WATER QUALITY CONTROL COMMISSION  
STATE OF COLORADO

RESPONSIVE PREHEARING STATEMENT OF  
CHATFIELD WATERSHED AUTHORITY

IN THE MATTER OF PROPOSED ADOPTION OF REVISIONS TO THE BASIC STANDARDS AND METHODOLOGIES FOR SURFACE WATER (REGULATION NO. 31); REVISIONS TO CLASSIFICATIONS AND NUMERIC STANDARDS FOR ARKANSAS RIVER BASIN (REGULATION NO. 32), UPPER COLORADO RIVER BASIN AND NORTH PLATTE RIVER (PLANNING REGION 12) (REGULATION NO. 33), SAN JUAN RIVER AND DOLORES RIVER BASINS (REGULATION NO. 34), GUNNISON AND LOWER DOLORES RIVER BASINS (REGULATION NO. 35), RIO GRANDE BASIN (REGULATION NO. 36), LOWER COLORADO RIVER BASIN (REGULATION NO. 37), AND SOUTH PLATTE RIVER BASIN, LARAMIE RIVER BASIN, REPUBLICAN RIVER BASIN, SMOKY HILL RIVER BASIN (REGULATION NO. 38); REVISIONS TO NUTRIENTS MANAGEMENT CONTROL REGULATION (REGULATION NO. 85)

## **Technical Review of Information Related to Development of Revised Nutrient Criteria for Colorado Lakes**

Figure 4. Variation in sample number (growing-seasons means) across lake-years for TP and chlorophyll *a* (left panel) and TN and chlorophyll *a* (right panel).

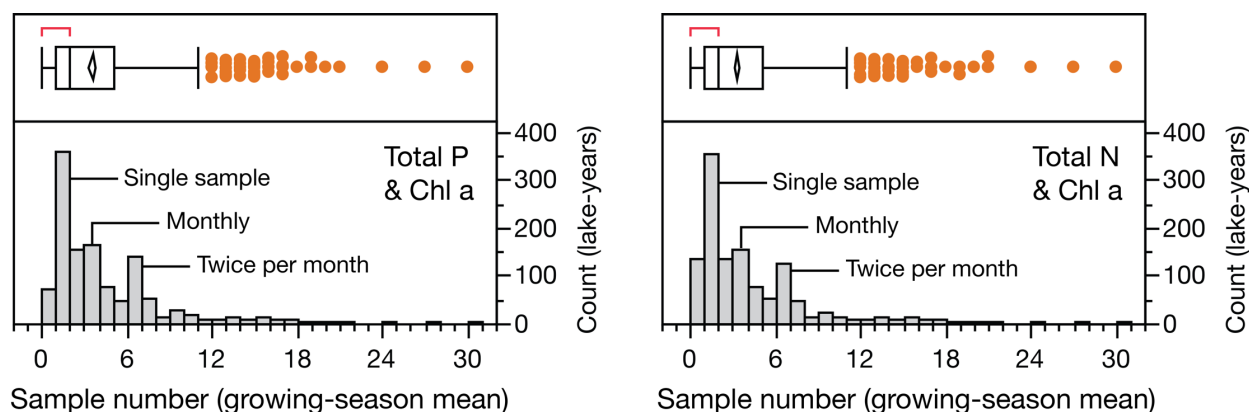
*Minimum sample size* – The WQCD and Tetra Tech determined that a single sampling event within the July – September season would be adequate for calculation of seasonal-mean values used for development of the proposed criteria. Additionally, the WQCD has indicated its intent to change the 303(d) listing methodology for lakes, such that the sample-size requirement for seasonal means (chlorophyll *a*, TP, TN) would be reduced from at least three samples ( $n \geq 3$ ) to a single sample ( $n \geq 1$ ). The WQCD explained in the PPHS that a requirement of  $n \geq 3$  would limit its ability to assess lakes on a statewide basis. A single sample ( $n = 1$ ) per lake-year was the most common for the sPHS data set, followed by monthly sampling ( $n = 3$ ) and two samples per month ( $n = 6$ ; Figure 4).

Figure 8. Effect of sample number on range of seasonal-mean values for chlorophyll *a*, total phosphorus, and total nitrogen for Colorado lakes.

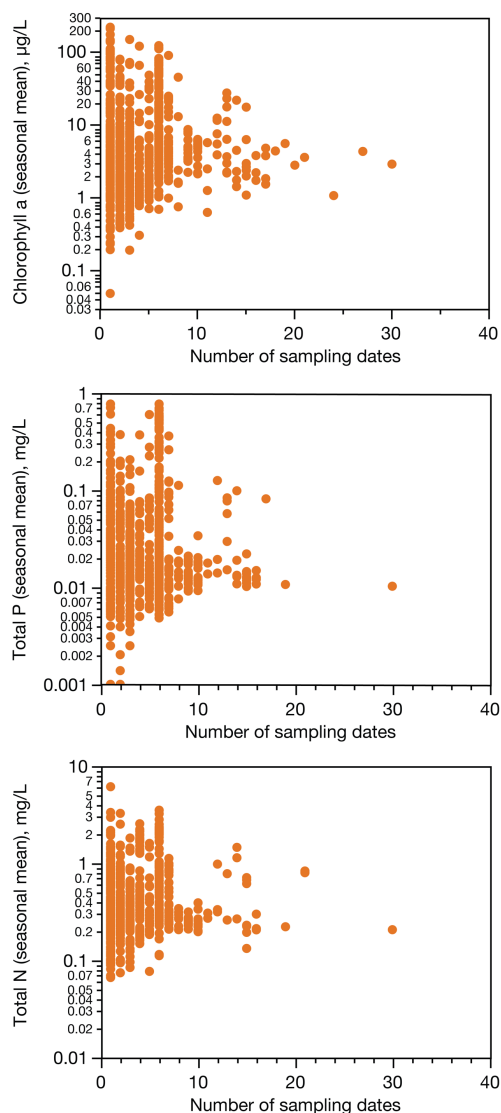
Analysis of the sPHS data set further illustrates the effect of sample size on variation in seasonal-mean values (Figure 8). For lakes that were sampled eight or more times during the July – September season, seasonal-mean values of chlorophyll *a*, TP, and TN fall within a range of about 1.5 – 2 orders of magnitude. For lakes that were sampled only once during the July – September season, the seasonal means vary over a range of about 3 orders of magnitude.

The relationships shown in Figures 8 – 10 indicate that three sampling dates would be inadequate for reliable determination of seasonal-mean values for some lakes, particularly for mesotrophic and eutrophic lakes. Figure 11 shows the effect of sample size on the log-linear relationships between chlorophyll *a* and nutrient concentrations for Colorado lakes. The slopes of the relationships are affected by sample size for this data set, and the relationships are much stronger for means with large sample size ( $n \geq 5$ ;  $r^2 = 0.67$  for TP and  $r^2 = 0.79$  for TN) than for means with small sample size ( $n \leq 2$ ;  $r^2 = 0.40$  for TP and  $r^2 = 0.38$  for TN). The WQCD also found that nutrient-chlorophyll relationships are stronger for seasonal means ( $n \geq 3$ ) than for grab samples ( $n = 1$ ; Ex. P, 2012 WQCD rebuttal Exhibit 24), and many examples from the peer-reviewed literature (e.g., Jones et al. 1998) support the conclusion that a small sample size is inappropriate for both development and assessment of nutrient criteria.

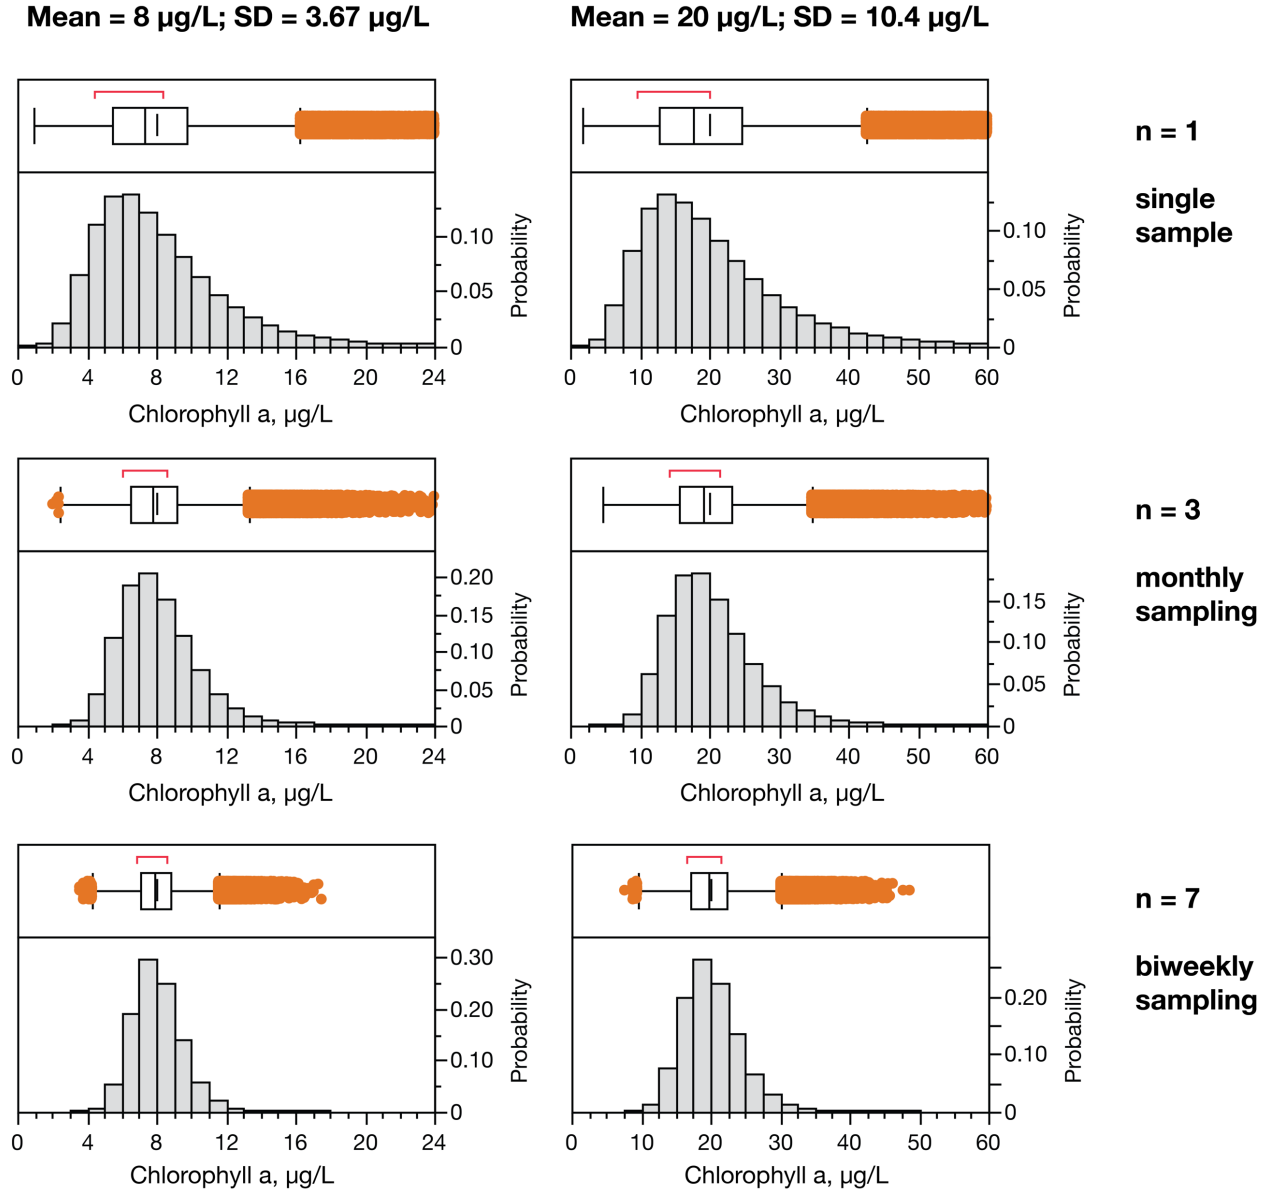
Figure 10 shows the effect of sample size ( $n = 1$ ,  $n = 3$ ,  $n = 7$ ) on expected variation in

seasonal-mean chlorophyll *a*. Although the range of variation decreases markedly with increasing sample size, seasonal-mean values for  $n = 7$  extend from about 50% of the true mean to about 50% above the true mean. Even with 25 samples over the July – September season (i.e., sampling about twice per week) for a lake with a true seasonal mean of 8 µg/L chlorophyll *a*, the probability of a calculated seasonal mean greater than 9 µg/L is almost 10%. If uncertainty in seasonal means and the relationship between sample size and uncertainty are not considered in assessments, many lakes could be incorrectly listed for impairment, or incorrectly listed as unimpaired.

Figure 12. Water temperatures (July – September) for Cold and Warm lakes. Boxes show medians, 25<sup>th</sup> percentiles, and 75<sup>th</sup> percentiles; whiskers show ranges, except values more than 1.5 times the interquartile range are shown as outliers (orange symbols).

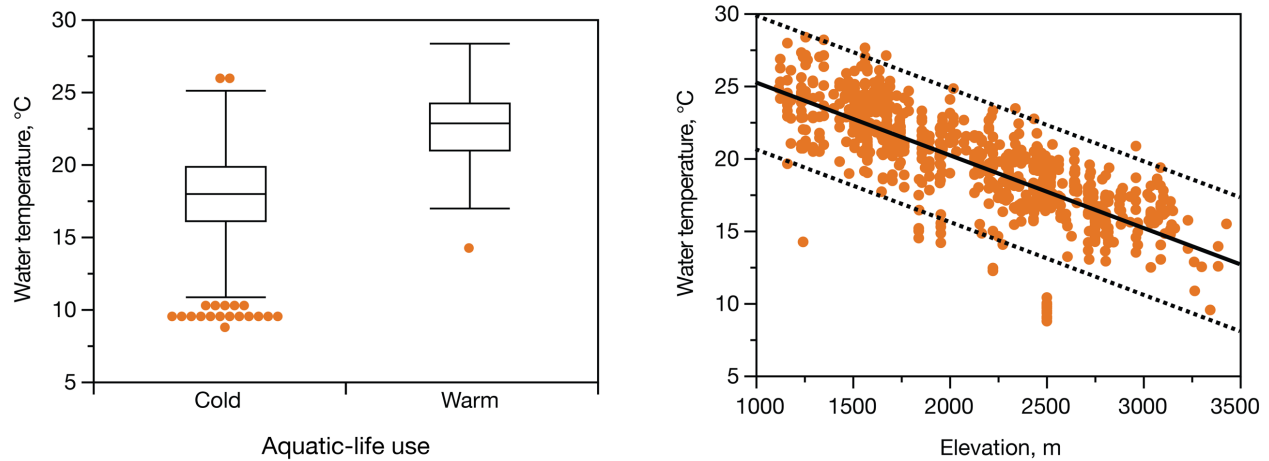
Seasonal-mean temperature differs significantly between Aquatic Life Cold and Aquatic Life Warm lakes in Colorado, but there is substantial overlap in temperature between Cold and Warm lakes (Figure 12). Algal growth is more directly related to temperature than to Aquatic Life Use, but temperature was not considered as a variable for partitioning the data set. Also, algal growth in lakes varies with lake depth and water-residence time, but neither depth nor residence time was considered by Tetra Tech as a partitioning variable. Furthermore, the Tetra Tech Report does not provide enough information to evaluate whether Aquatic Life Use is the most appropriate variable for partitioning the relationships between nutrient concentrations and chlorophyll *a*. Decisions about lake classification (and covariates for regression analyses, see below) are important for development of nutrient criteria because statewide relationships between chlorophyll *a* and any single variable (TP, TN, temperature, depth, water-residence time, etc.) can have poor predictive power, particularly for analyses of grab-sample ( $n = 1$ ) data.

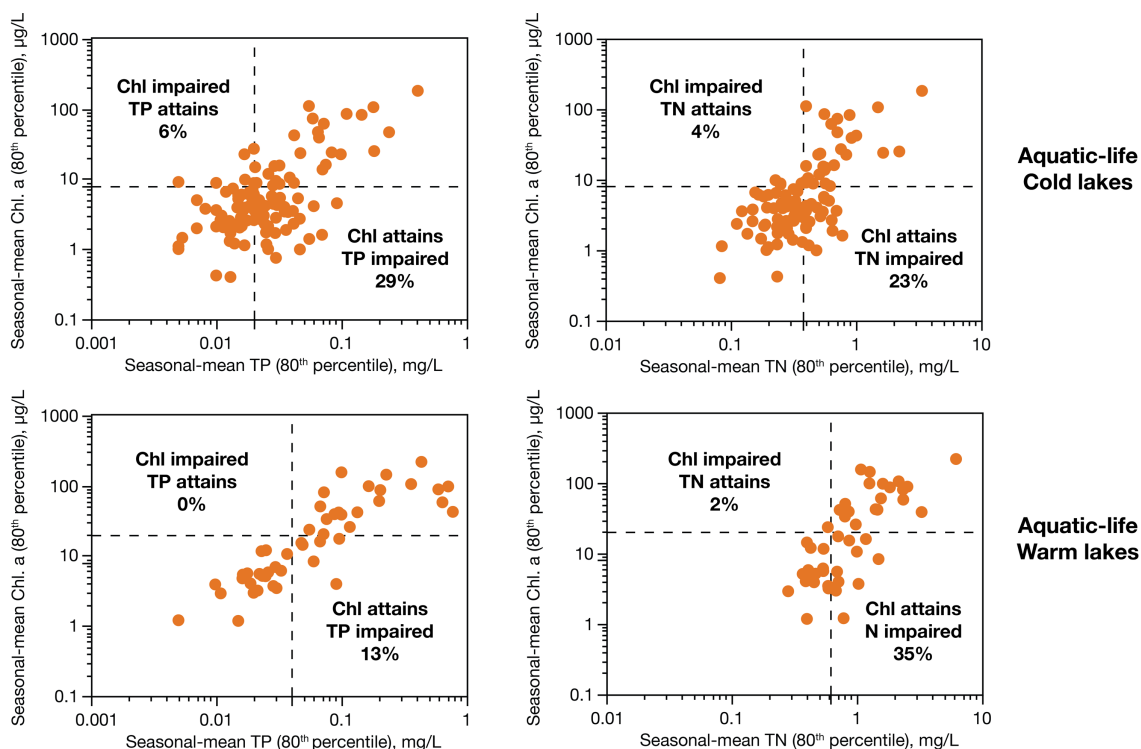
Information about projected attainment of the proposed standards is shown in Figure 14. These data indicate that about 30% of Cold lakes and over 40% of Warm lakes in the sPHS data are impaired for chlorophyll *a*. However, the seasonal-mean values for TP and TN would exceed the proposed table values in four of five years for 55 – 65% of lakes in the data set. Lakes that fall in the lower right quadrant of the graphs in Figure 14 indicate over-protection with regard to TP or TN (i.e., attainment of the chlorophyll *a* standard without attainment of the TP standard or TN standard).
